GENOA CHARTER TOWNSHIP BOARD
Regular Meeting
June 19, 2017
6:30 p.m.

5. Consideration of a request for approval of special land use, environmental impact assessment and site plan for a proposed 30,000 sq.ft. warehouse/storage addition to the existing A & F Wood Products located at 5665 Sterling Drive, Howell. The request is petitioned by Schonscheck Inc.

Attention:	Kelly Van Marter, AICP Planning Director and Assistant Township Manager
Subject:	A&F Wood Products – Special Land Use and Site Plan Review #2
Location:	5665 Sterling Drive – terminus of Sterling Drive, west of Dorr Road
Zoning:	IND Industrial District

Re: A&F Wood Products Addition Site Plan Review #2

SHEET TITLE:
BUILDING ELEVATIONS

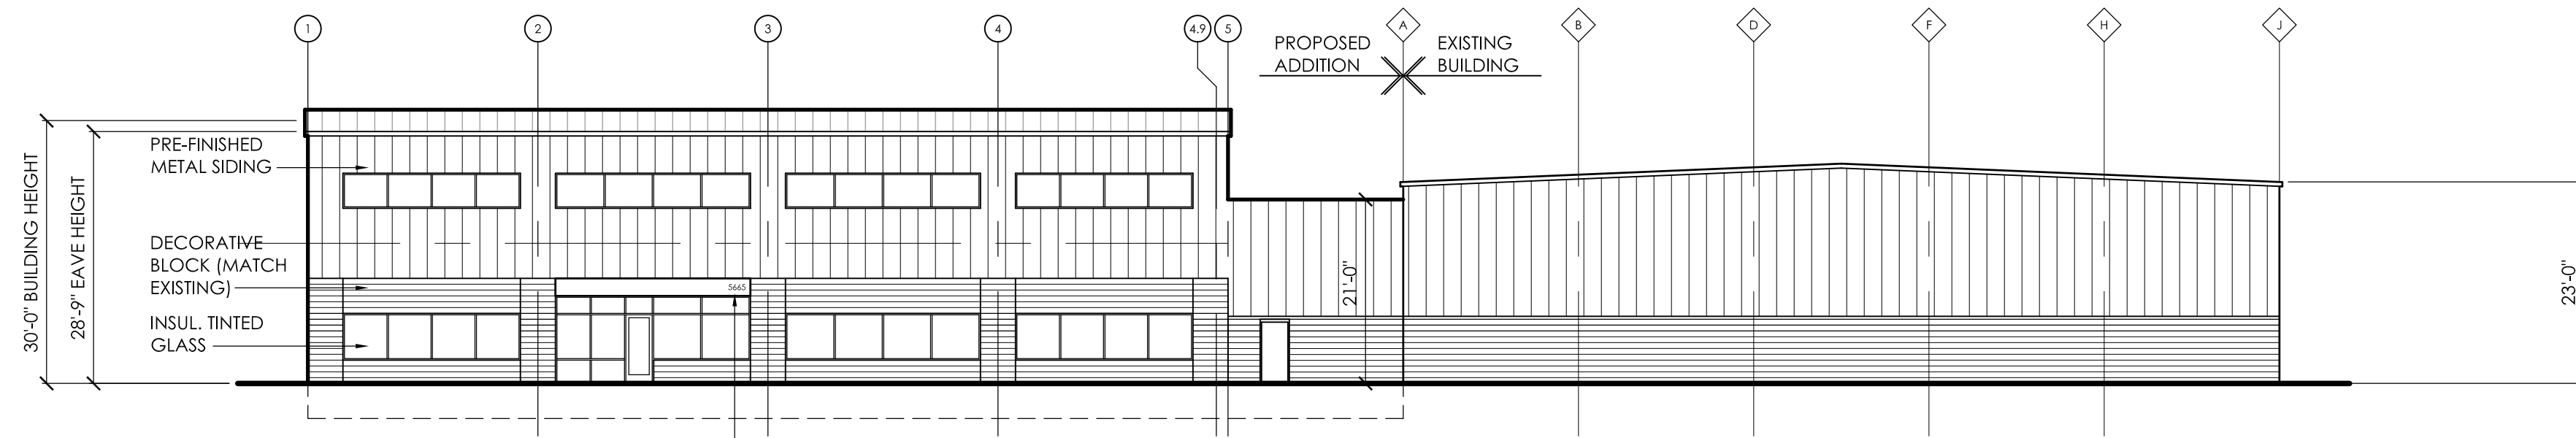
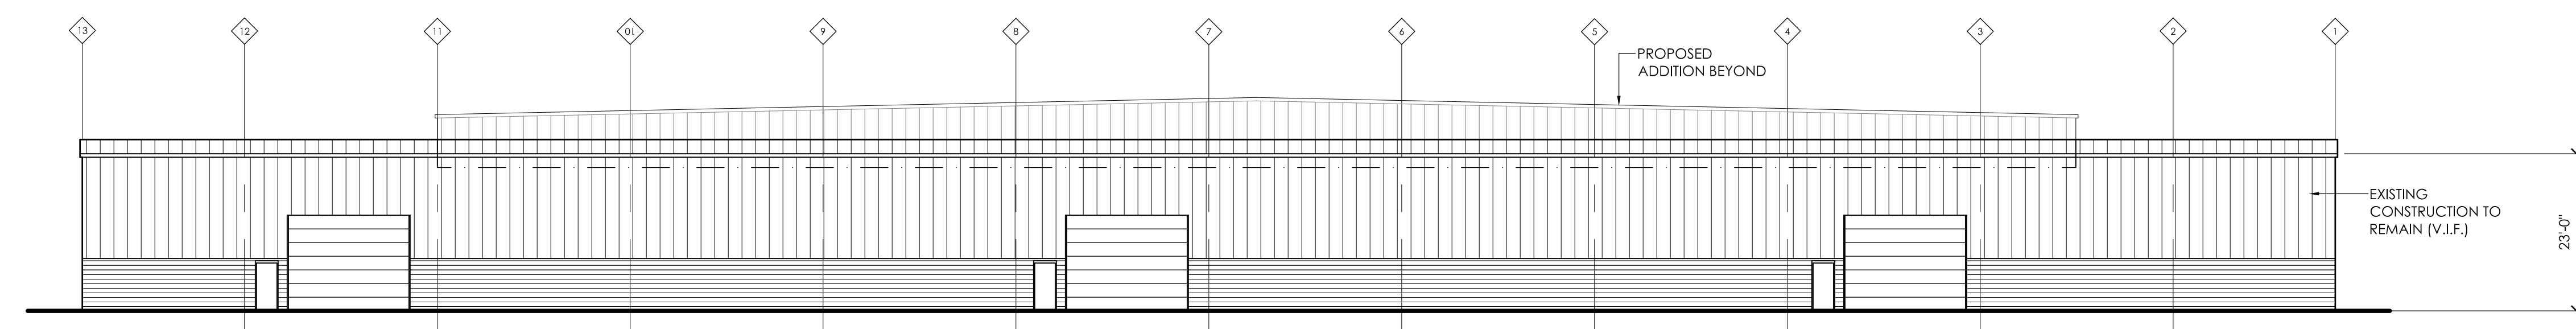
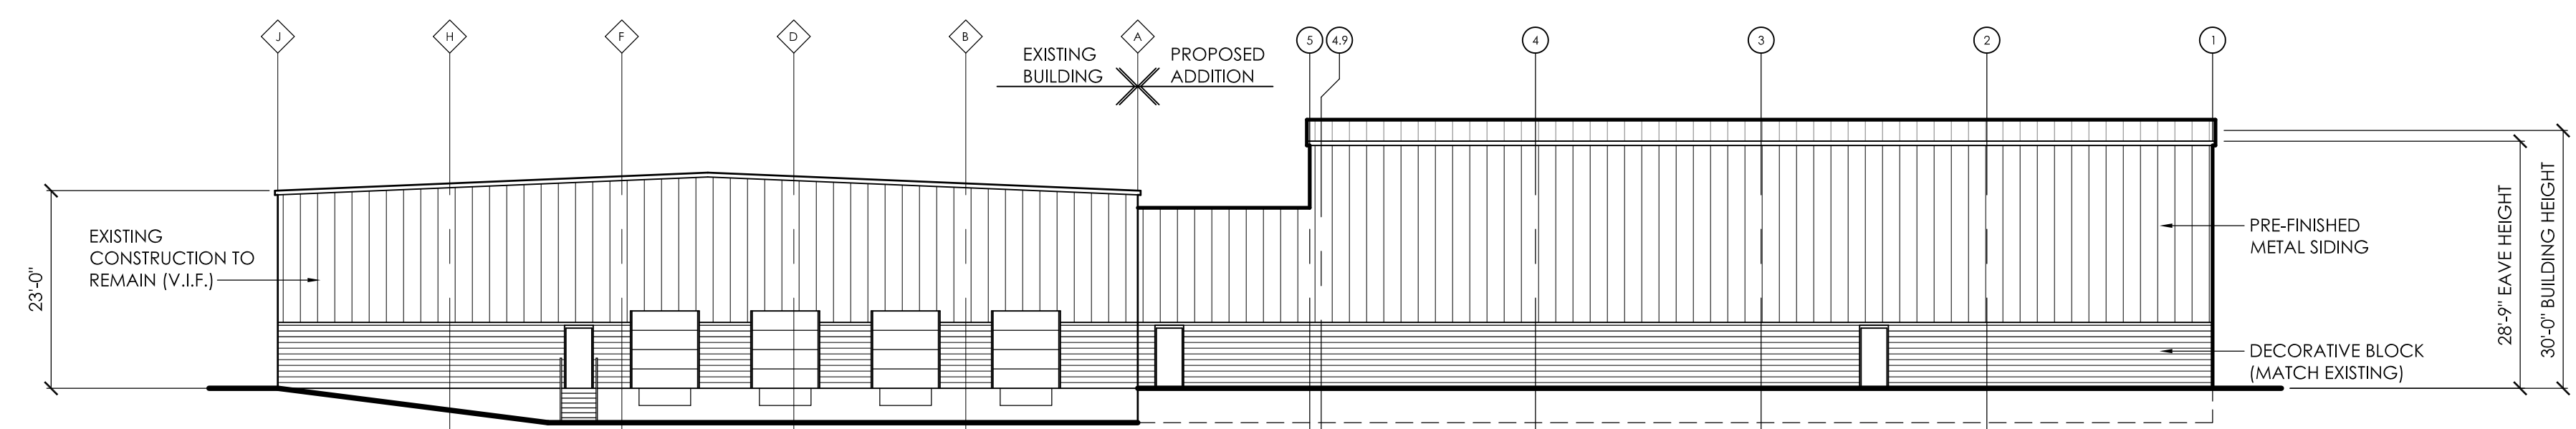
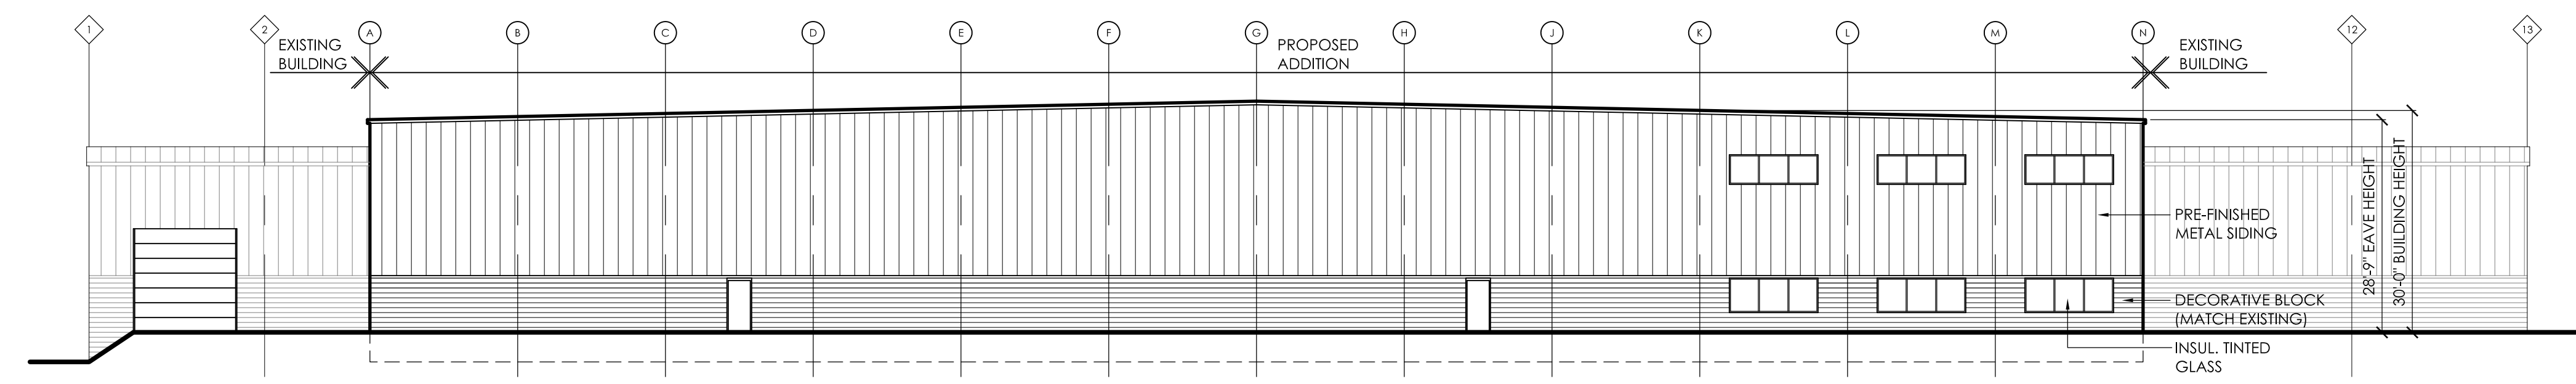
The revised submittal includes material calculations demonstrating that the amount of metal siding exceeds the limitations of Section 12.01.03. More specifically, the Ordinance restricts the use of metal siding to no more than 25% of a wall face visible from a parking lot or roadway. The north, south and east elevations are all well in excess of 25%.

With that being said, the building elevations note that materials, design and colors will match the existing building. The Ordinance gives Planning Commission the discretion to modify these requirements under certain circumstances, such as when an addition is consistent with the existing building.
